# 2000 Corvette: Service Bulletin: Tech - Left Headlamp Door Does Not Stay Closed

**Number:** 00-08-42-002

**Subject:** Tech - Left Headlamp Door Does Not Stay Closed

**Model Year:** 2000

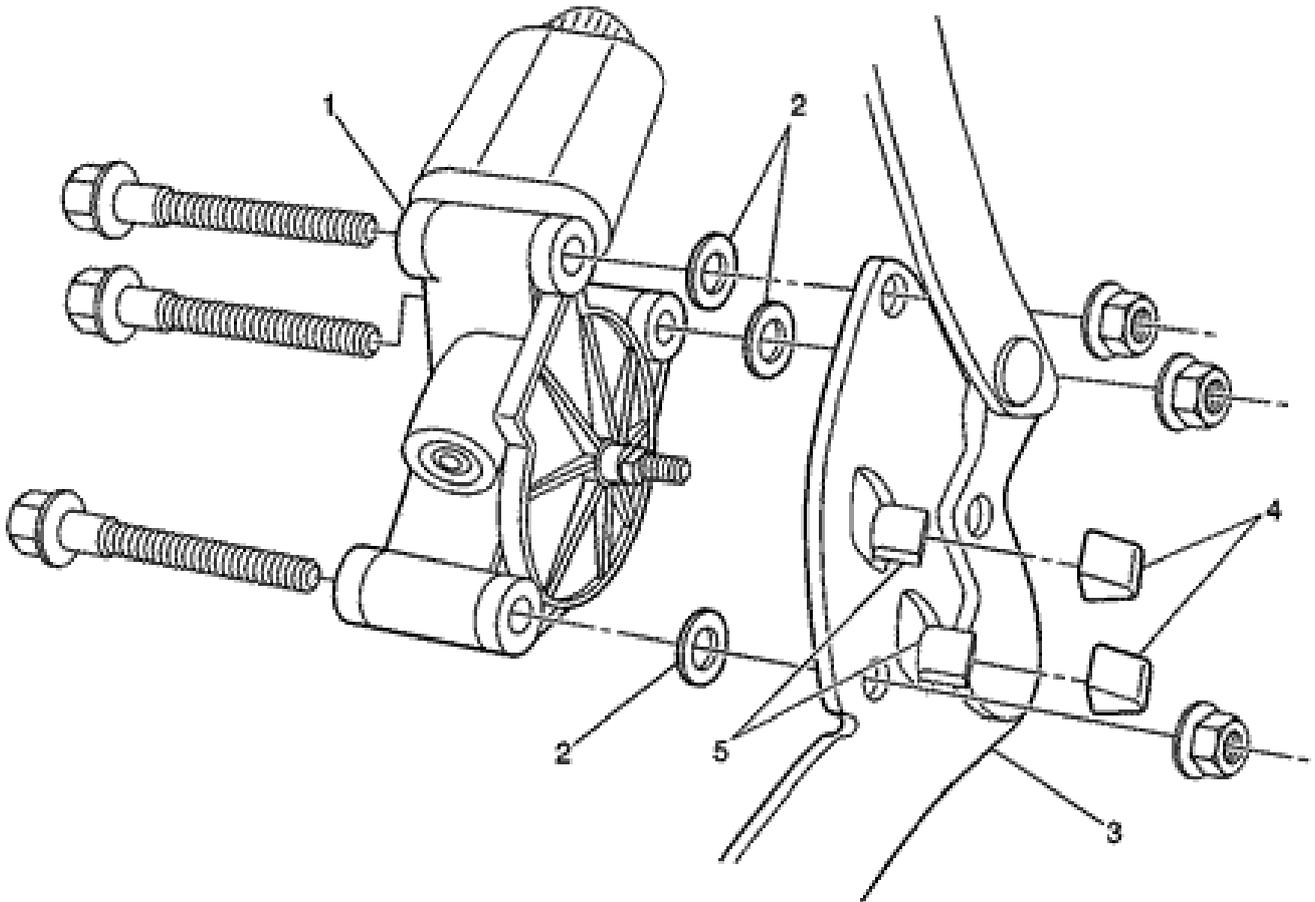
Some customers may comment that the left front headlamp door does not remain closed after the headlamps are turned off. Others may comment that the left headlamp door closes when the headlamps are turned off, but then reopens. In either case, the right headlamp door operates properly.

Install one washer (2) between the left headlamp door motor/actuator (1) and the mounting bracket (3) at each of the three attaching bolt locations. Also replace the insulator (4) on each of the two mounting bracket travel stop tabs (5) as shown. For information on headlamp motor/actuator removal, see the Headlamp Motor/Actuator Replacement procedure in the Lighting sub-section of Body & Accessories in the appropriate Service Manual.
